Standard Development Timeline

This is the second draft of the proposed standard being posted for a formal 45-day comment period and additional ballot.

1. **Title:** Coordination of Generating Unit or Plant Capabilities, Voltage Regulating Controls, and Protection
2. **Number:** PRC-~~019-2019-3~~
3. **Purpose:** To verify coordination of generating unit or Facility ~~or synchronous condenser~~-voltage regulating controls, limit functions, equipment capabilities, and ~~Protection System settings~~ protective functions.

Section G Attachment 2 — Example of Capabilities, Limiters, and Protection on an R-X Diagram at nominal voltage and frequency

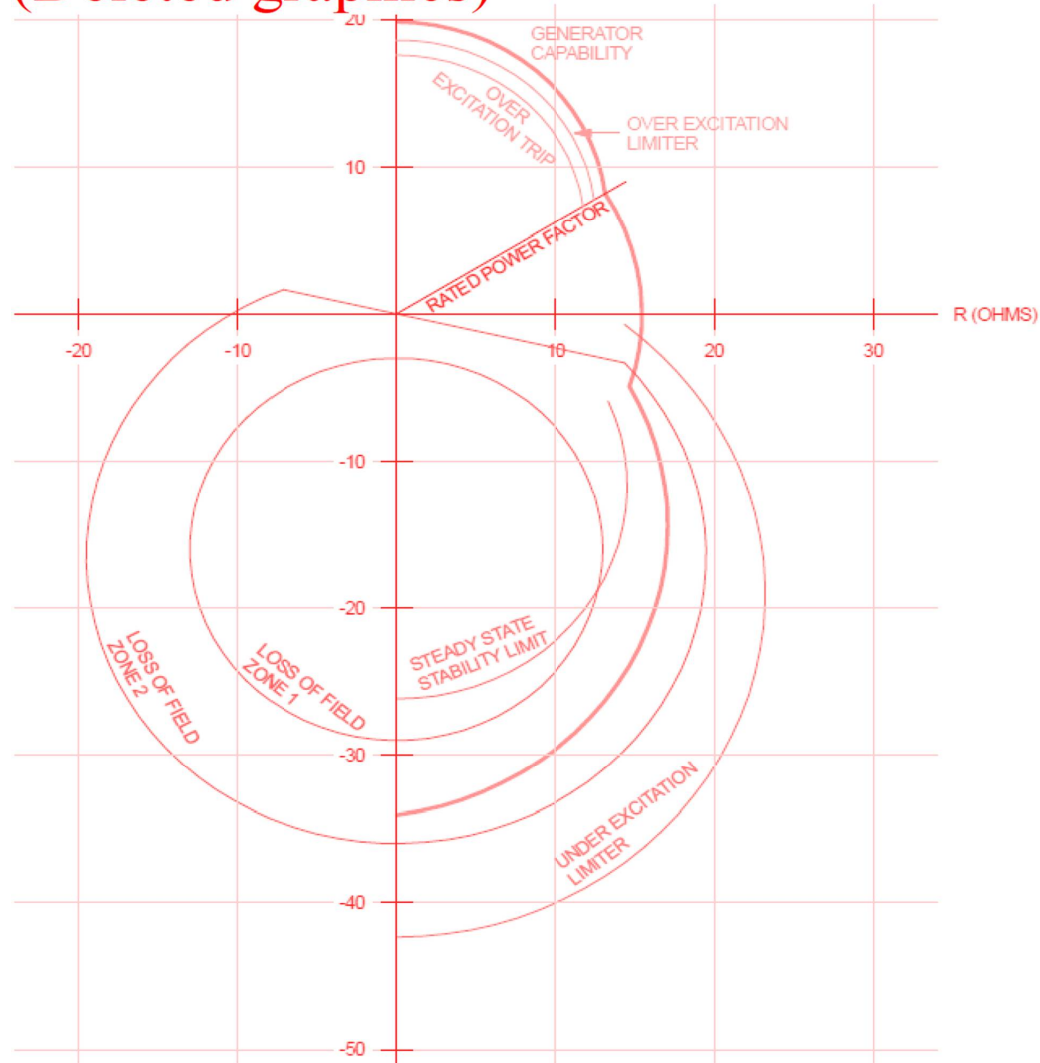
(Deleted graphics)
